GG-H-0080a (DSA-DM)
AMENDMENT-1
9 September 1970

INTERIM FEDERAL SPECIFICATION

HANDLE AND BLADE SET, SURGICAL KNIFE, DETACHABLE BLADE

FIGURE 4[illegible].-

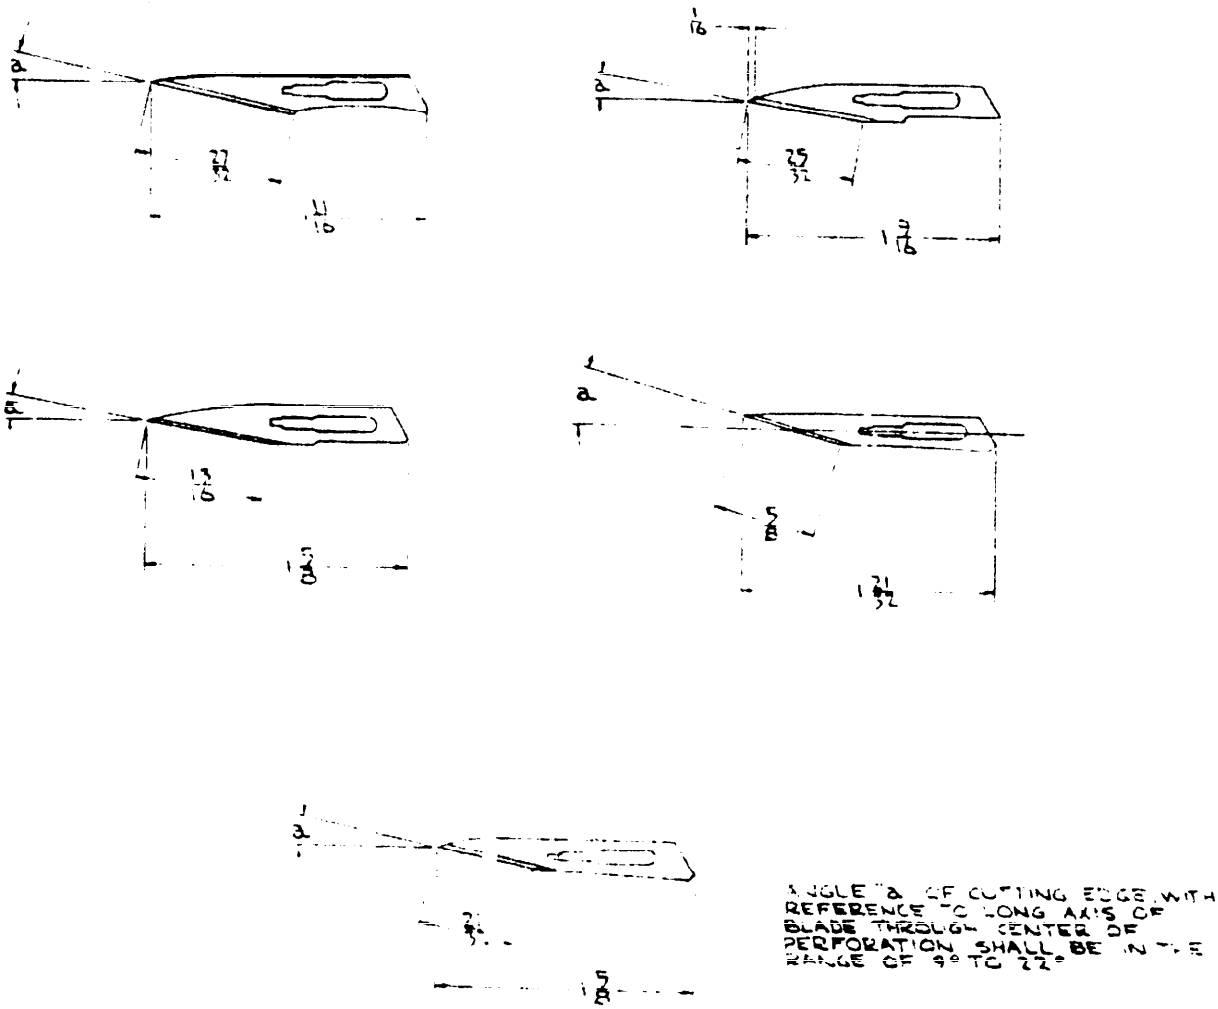
3.6.1 Design. Second sentence, delete period and add ", except that figure 4C' shall apply instead of figure 4C". After second sentence, insert "However, for the Type EE blade shown in figure 5e delete "6°/9°" and substitute "5-1/2° to 8-1/2°". Before last sentence insert "Type EE blades, however, shall be thicker along back edge for the purpose of reinforcement."

ANGLE "a" OF CUTTING EDGE WITH REFERENCE TO LONG AXIS OF BLADE THROUGH CENTER OF PERFORATION SHALL BE IN THE RANGE OF 9° TO 22°.

FIGURE 10.- ENLARGED VIEW OF DIMENSION "C" (OF FIGURES 3 AND 6) AND EQUIVALENT DIMENSION "C" IN FIGURE 8

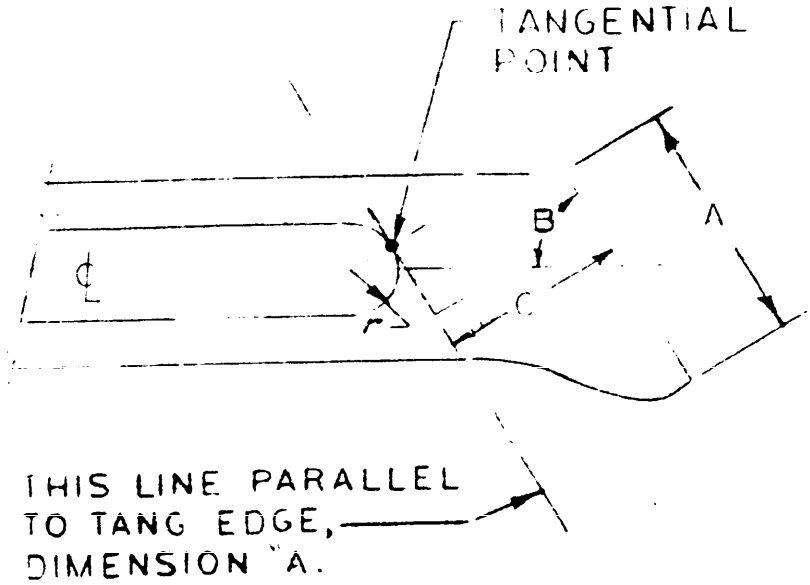
3.6.2 Tang. Line 4 after "6" add "and figure 10". Last line delete "the" and add "6" after "figure". Add the following to the end of the paragraph: "Dimensions of blades shall be checked by Go and No-Go gages (figure 8) as described in 4.4.1. Blades not passing Go and No-Go gages shall then be subjected to examination by means of a comparator as stated in 4.4.1.1. Blades not passing the dimensional examination on the comparator shall be rejected.
